LETTER AND RESPONSE TO REGULATOR COMMENTS ON FOURTH FIVE-YEAR REVIEW
REPORT NIROP FRIDLEY MN (PUBLIC DOCUMENT)
9/27/2013
TETRA TECH

Subject: Responses to Comments - Fourth Five-Year Review Report
NIROP Fridley, Fridley, Minnesota

**RESPONSES TO EPA COMMENTS ON THE FOURTH FIVE-YEAR REVIEW
REPORT
DATED MAY 2013**

**NAVAL INDUSTRIAL RESERVE ORDNANCE PLANT
FRIDLEY, MINNESOTA**

Legend

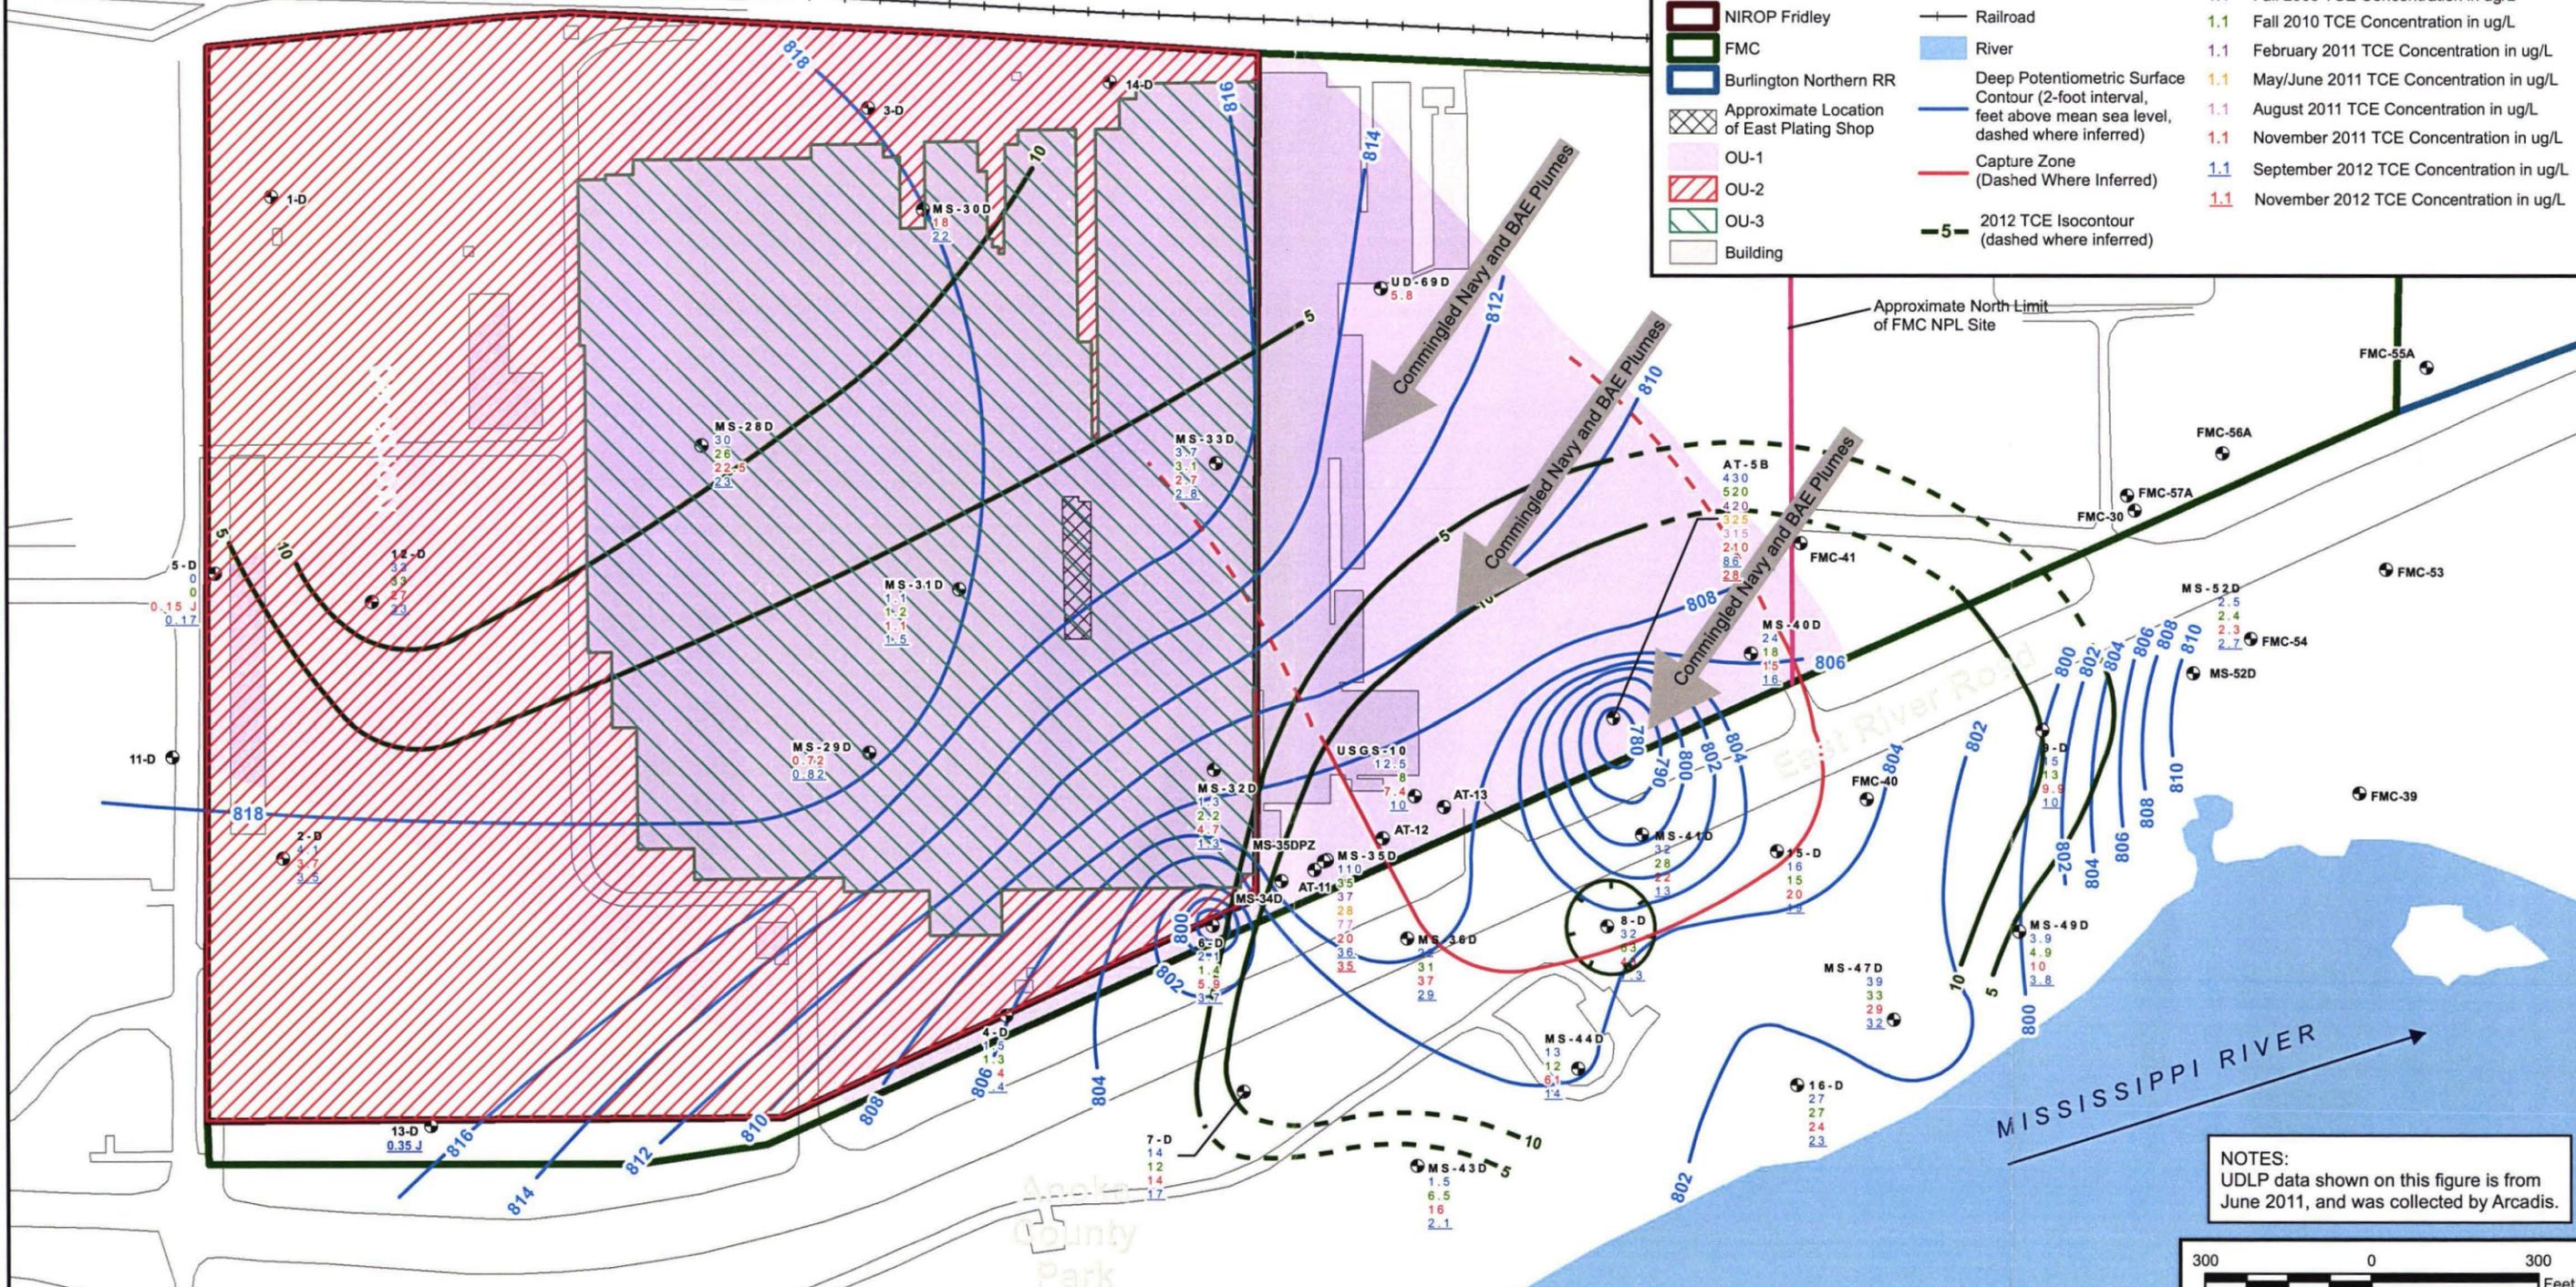
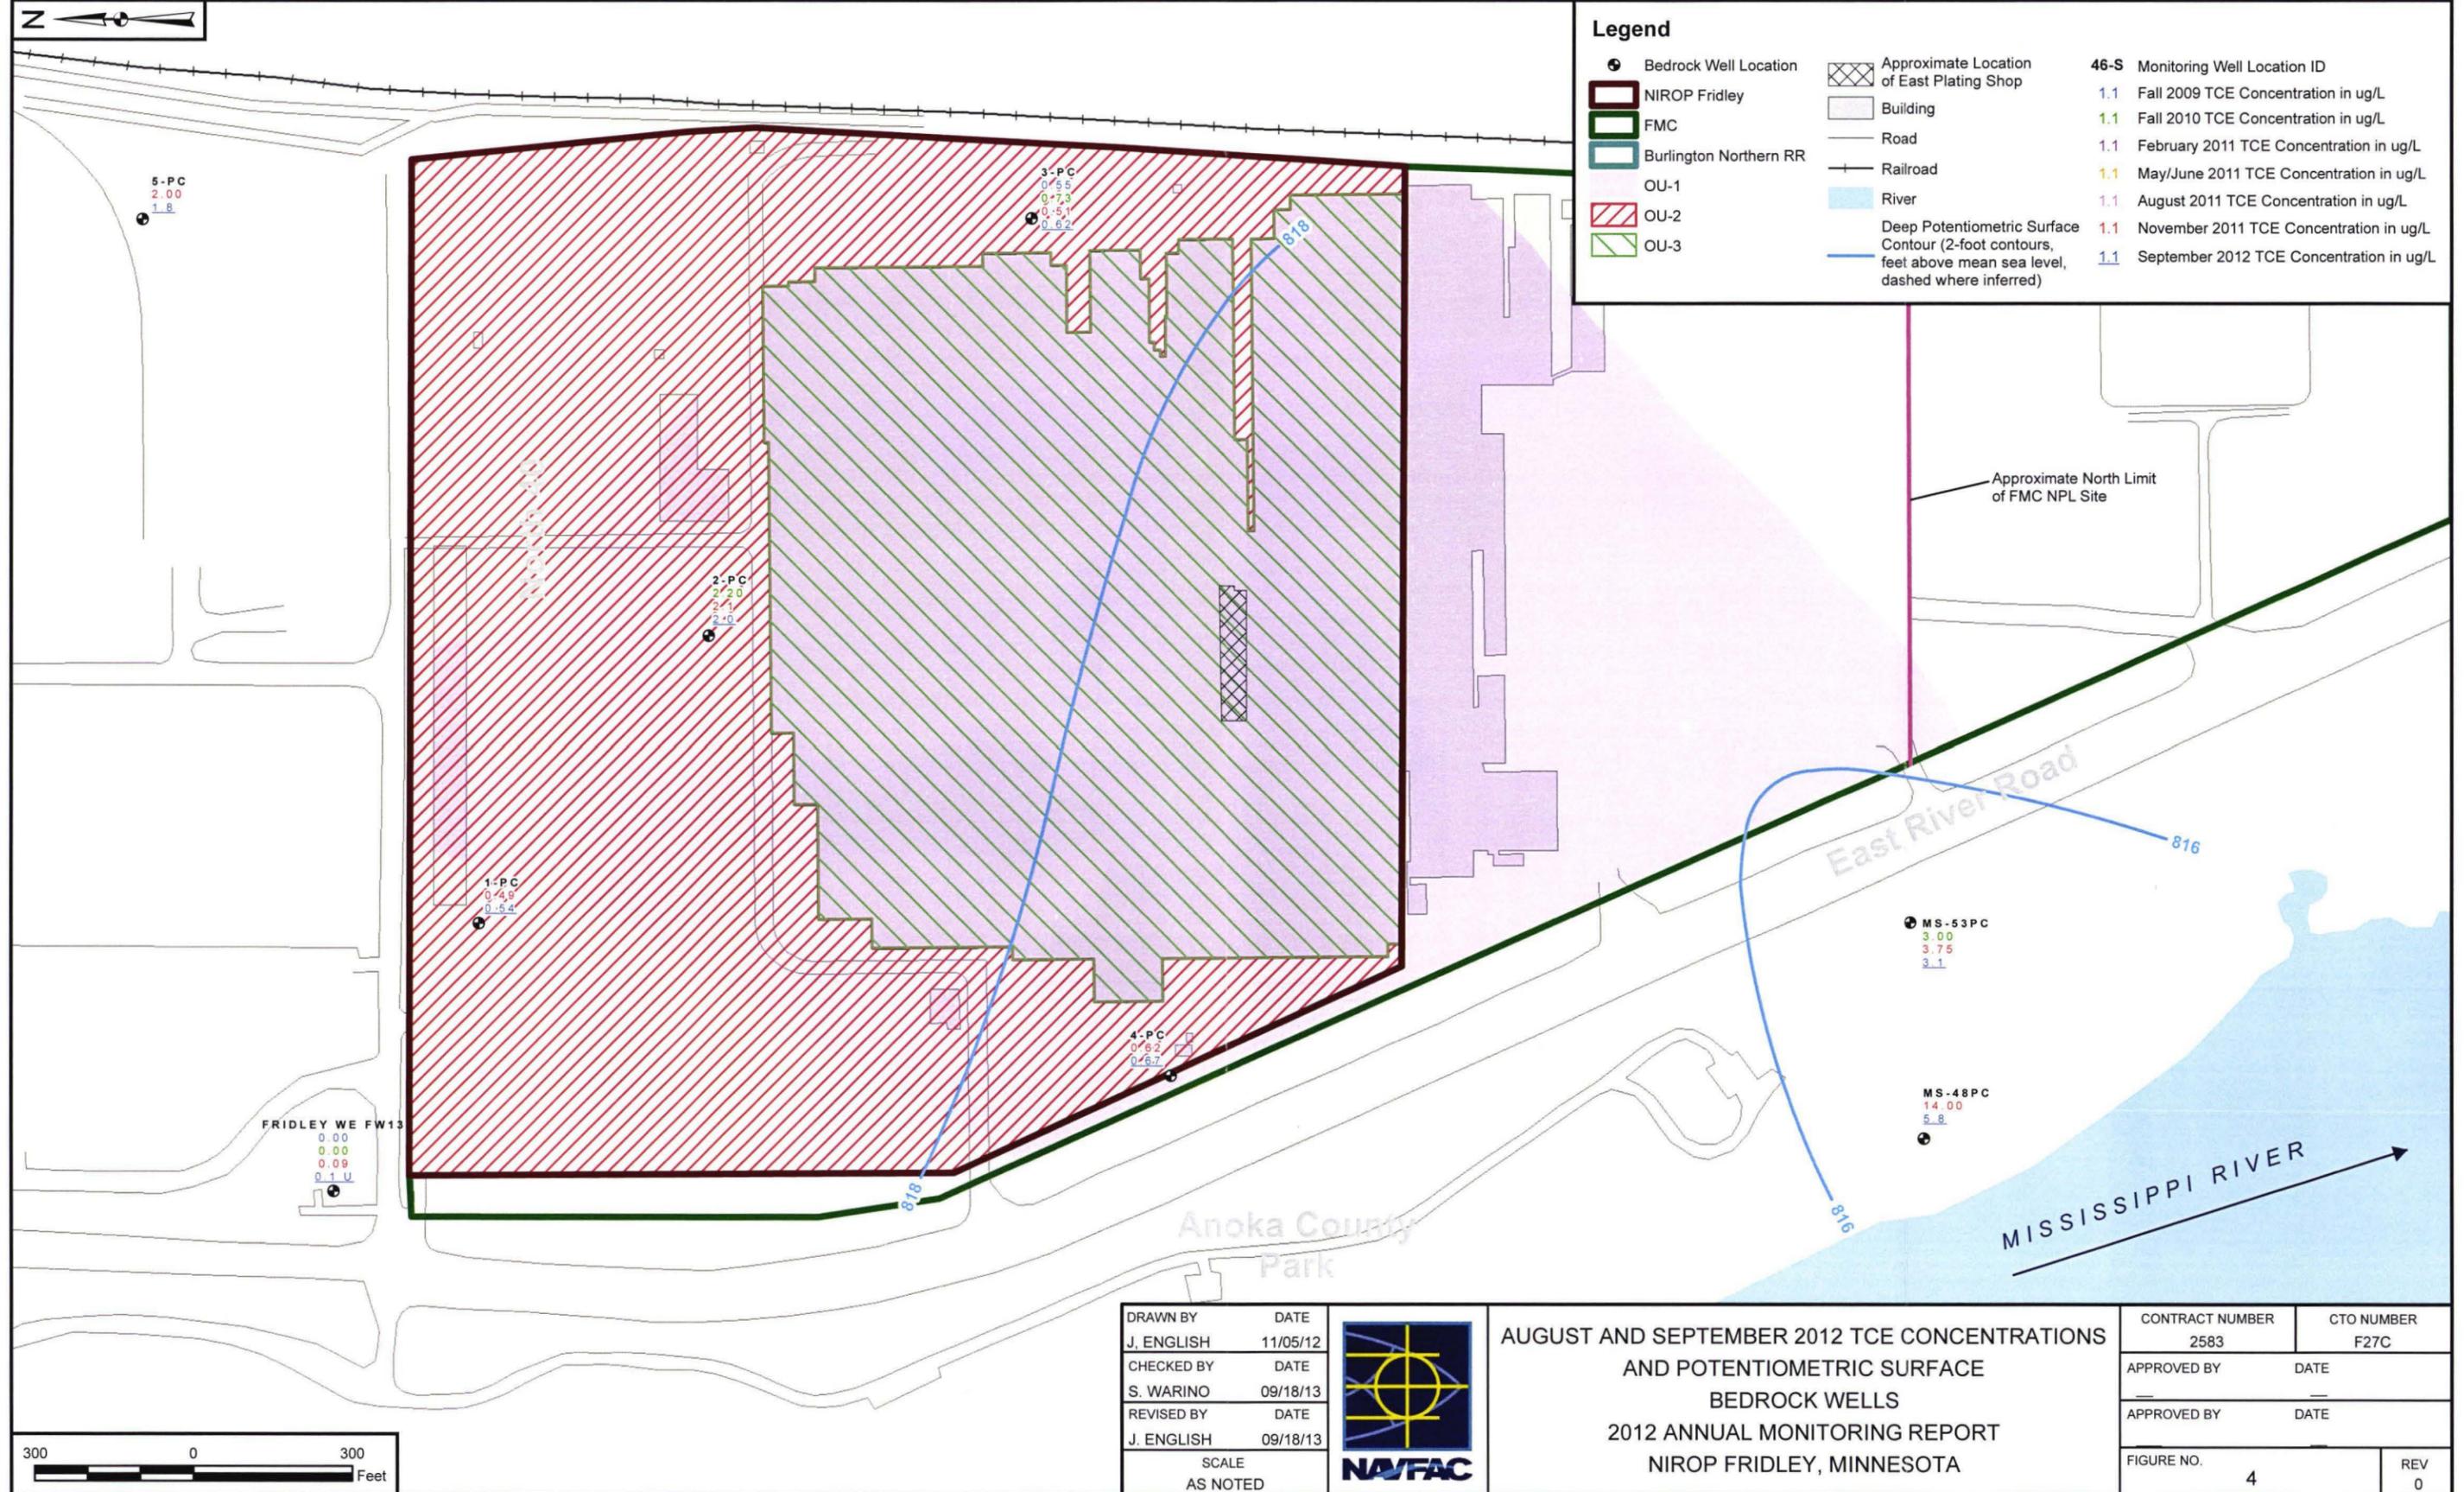
12. Comment: Section 7.2.5.1, Problem B: Effectiveness of the Capture Well System, Page 7 of 9: The last sentence of Section 7.2.5.1 references Attachment 3 as support that the system continues to show significant improved performance; however, Attachment 3 (TCE Isoconcentration Maps and Approximate Capture Zone Configurations) includes TCE isoconcentration maps and the approximate capture zone configurations. These do not show significant improved performance of the system. Revise Section 7.2.5.1 to reference figures and tables which support that the system continues to show significant improved performance.

Response: The following text has been added just before the reference to Attachment 3: “and effectiveness in capturing contaminated groundwater”. The figures are meant to show substantial capture of contaminated groundwater.
